We would like to thank all reviewers for their valuable insights and comments made to improve this work. We believe we have addressed all comments made by the reviewers as shown below, and the suggested changes have greatly improved this manuscript.

Review #1

New Figure 2:

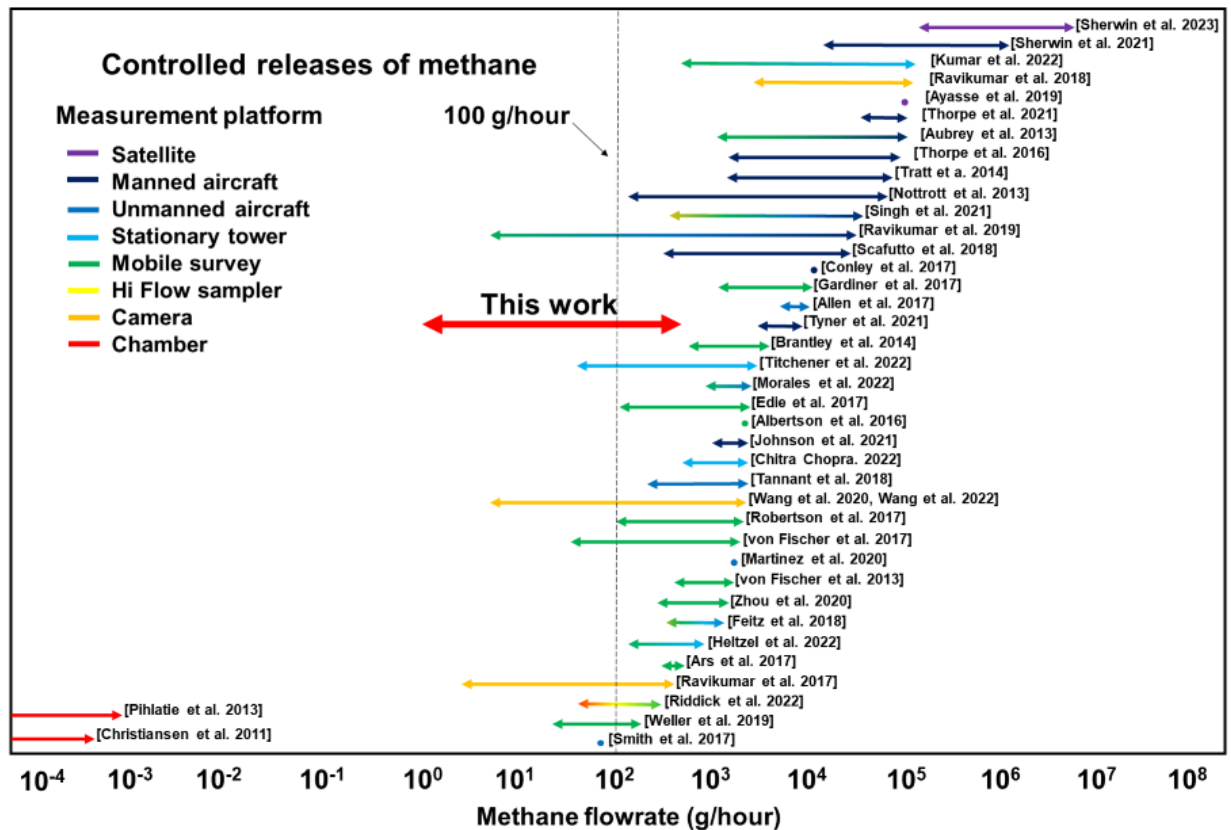
In addition to the changes outlined below for this reviewer, we also performed additional edits that we believe improve on the current version of the manuscript without significantly altering any results. First, we address some previously unmentioned methods we used for the linear regressions for controlled releases where methane concentrations were expected to rapidly reach steady-state. We also modified our presentation of the accuracy of measurements to encapsulate the median of the over- and underestimates to better represent the bias in our measurements. Finally, we incorporated two new studies on prior controlled releases into Figure 2 and the subsequent analysis section. The changes are outlined as follows:

Line 140: **“For some experiments, methane concentrations within the chamber were expected to rapidly reach steady-state. Steady-state is reached when methane concentrations no longer increase over time in the chamber and the concentration of methane within the chamber is equal to the concentration of the released gas. The residence time, or time to reach steady-state, is defined by (2): where τ is the residence time, V is the volume of the chamber, and Q is the volumetric flowrate of gas (i.e., methane and balance gas combined) into the chamber. For any controlled releases where the expected residence time was two minutes or lower, we only used the initial ten data points for the linear regression to avoid the period of exponential decay as methane concentrations approach steady-state (Pihlatie et al., 2013).**

For each factor being investigated, we grouped the results depending on whether the measurement was an under- or overestimate of the true methane flowrate. We calculated the accuracy of measurements as a range spanning from the median of the over- and underestimated methane flowrates, respectively. We determined the bias of measurements as the average of the raw percentage errors to determine whether tests were biased more towards the under- or overestimation of methane flowrates. “

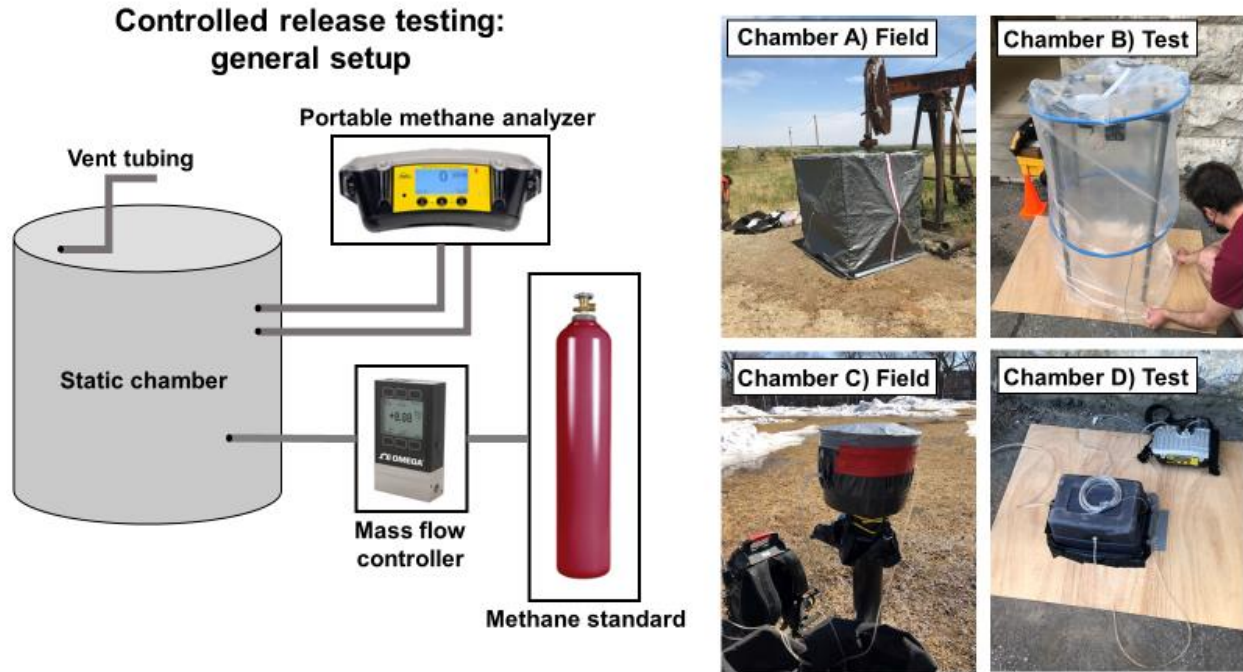
Figure quality can be improved and below I suggest adding more figures on the actual chamber designs and chamber measurements to make it more tangible for the reader.

We agree with the reviewer and have modified all figures in this work. Figure 1 was modified to include two controlled release tests that were not included in the original submission. Figure 2 was modified with small aesthetic changes. Figure 3 was changed from violin plots to three scatter plots showing measured versus true methane flowrates, with the tested factors highlighted through the colour/size/shape of the points. We have also added a new Figure 1 to the manuscript that shows the general experimental design as well as pictures of all the tested chambers in either field settings or the controlled release experiment itself. We believe that having pictures of the chambers deployed in field settings adds additional information to the reader and gives good reference points for later discussion, especially for questions relating to chamber seal in-situ. We also deleted Figure 5 and replaced it with a figure showing four examples of raw data from the controlled releases.

New Figure 1

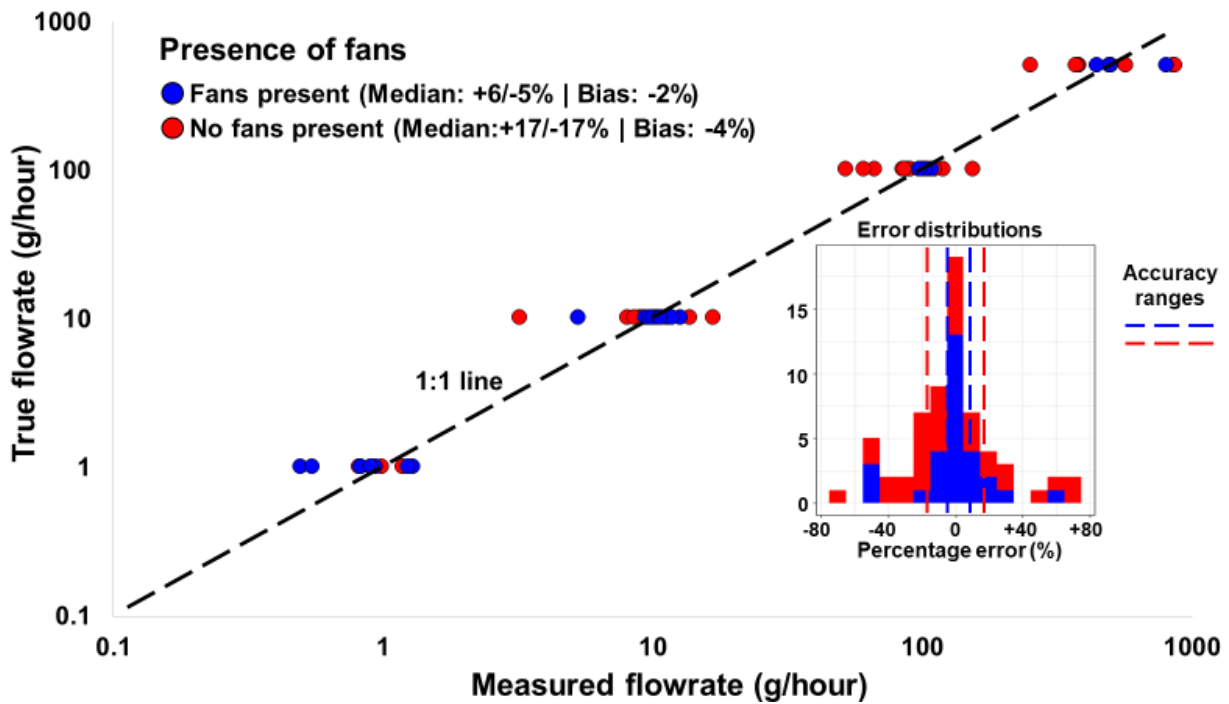
Your description of the experiment is clear, but I was missing pictures of your chambers in the field. This can provide valuable information for the reader wanting to do the same as you, but also help the reader/reviewer assess critical design aspects of your chambers that are not apparent, directly from your description in text. Also, since the chamber testing is the central element in your paper it deserves to be highlighted. Therefore, I suggest to make a new Figure 1 with four panels each showing the chambers A - D. Here it will also be obvious to show the methane delivery system and other important details.

We agree with your comments and have added a new Figure 1, as described earlier in this response. We have also added a new figure that shows the results of a subset of controlled release experiments that highlight a range of measurement accuracies and goodness-of-fits.

New Figure 8 that replaces old Figure 5

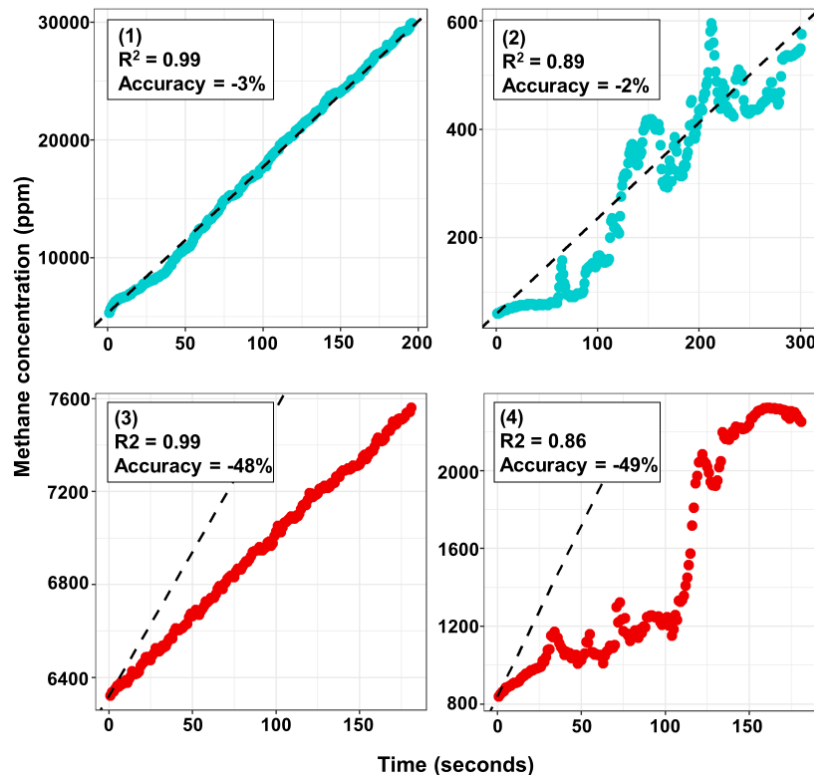
The violin plots are good to show the overall performance of the tests, but I was missing some more detailed plots on how actual chamber measurements (CH₄ concentration vs time) looked in case with good agreement (~1% error) and poor (>30% error) for both the small and large chambers under calm and windy conditions. In the main manuscript I would just highlight some examples and then in supplementary materials provide all 64 chamber enclosure measurements. In such a figure you could add the theoretical CH₄ concentration (e.g. what is dictated according to the release rate) and the actual observed concentration.

This is an excellent suggestion and we have adopted all of the suggested changes to the main manuscript and the SI. The changes are summarized as:

Line 258: "From all of the controlled release experiments we performed, we saw that the median error of +/-14% was lower than the mean error of 20%, indicating a heavy-tailed distribution of measurement errors. As such, we analyzed all controlled release experiments where the resulting error exceeded 40% to assess the potential cause of these erroneous measurements. A total of 12 controlled releases had quantification errors that exceeded 40% (SI - Figure S1). All of these experiments were conducted on larger volume chambers (i.e., 322L and 2,265L), and 8 of the 12 had no fans present. Based on a comparison of the fit of the linear regressions, we found that these 12 experiments did have lower R² values averaging 0.91 when compared to the rest of the dataset (mean R² = 0.96). Notably, 3 of the 12 high-error measurements had very high R² values exceeding 0.99, with an example being shown in Figure 8. We observed a similar phenomena with a single controlled release performed with an "ideal" and "non-ideal" chamber seal which is shown in the SI - Section 1, where a the "non-ideal" chamber seal produced a high R² value yet underestimated the methane flowrate by 43%."

meaning that they would be difficult to distinguish based on the goodness-of-fit of the measurement data alone. Furthermore, several experiments showed relatively poor R2 values but good measurement accuracy (Figure 8), adding to this difficulty. We also find that chamber shape is more important for larger chambers than smaller chambers, with the large cylindrical chamber performing better than the large rectangular chamber, whereas we did not find any difference between the smaller sized chambers with respect to shape. Ideally static chambers should be constructed to minimize potential "dead zones" where gases can accumulate (Christiansen et al., 2011), and cylindrical, or even spherical chambers, should facilitate easier mixing of air the chamber headspace."
